UNITED STATES PATENT AND TRADEMARK OFFICE

10/511,119

Office Action Summary	Application No. 10/511,119	Applicant(s) CARDINE ET AL.	
	Examiner Jerry Redman	Art Unit 3634

The request filed on 3/4/2009 for a Request for Continuing Examination (RCE) under 37 CFR 1.114 is acceptable and an RCE has been established. Any previous finality is hereby withdrawn and a new action on the merits follows. Any newly-submitted claims have been added. An action on the RCE follows.

Sheet 2 of 2

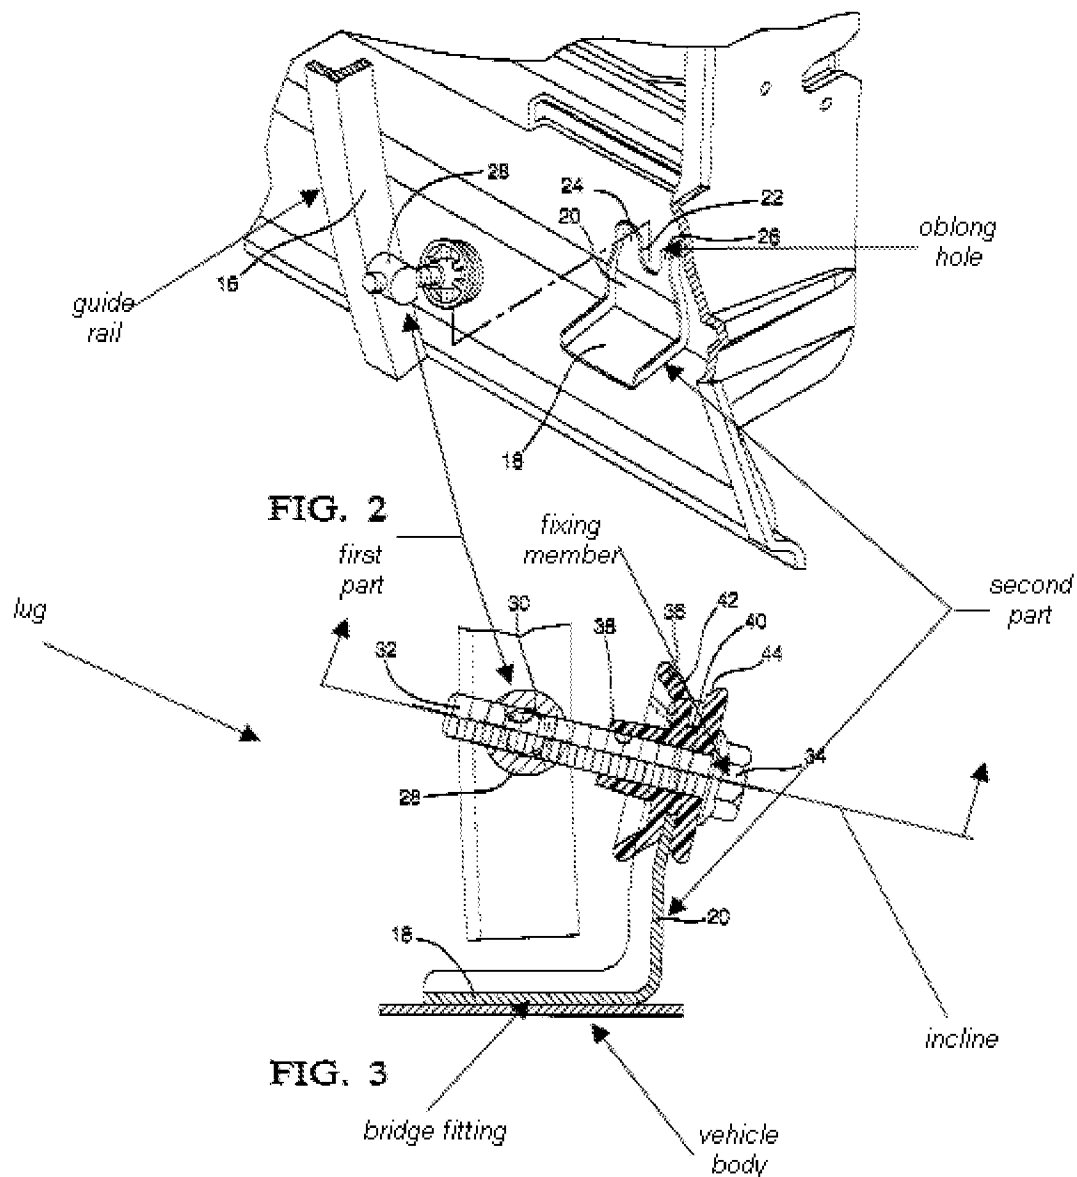
As best understood, claims 1-10, 12, 15, 17, 19, 21, and 23 are rejected under 35 U.S.C. 102(b) as being anticipated by Dedrich et al., (5,855,095). As shown in detail below, Dedrich et al., (5,855,095) disclose having a first part (28) connected to a guide

rail (16) which moves a window pane between an open and closed position, a second part "defining a single plane" fixed to the vehicle body (at 18) and having an oblong hole (22) for passage of a fixing member (34), and a bridge fitting (see figure below).

Furthermore, since the guide rail (16) is curved and the window opening and closing path is curved (i.e., guiding direction), then the second part defining a single plane and a normal line is substantially perpendicular to the single plane and inclined relative to the guiding direction.

The applicant's arguments have been considered but are not deemed persuasive. It appears that the applicant's arguments are more limiting than that of the claims. The applicant recites the second part as "defining a single plane" and states

that Dedrich et al. fail to disclose this limitation. It appears that the applicant has randomly picked what portions of what elements the applicant wants to define as the first and second parts yet the applicant has failed to positively recite the first and second parts in a structural manner to read over Dedrich et al. . The claims still read on the art of record as discussed in detail above. Furthermore, the upper portion of the second part (20) shown above defines a single plane wherein the lower portion of the second part is the attachment portion which attaches to the vehicle body.
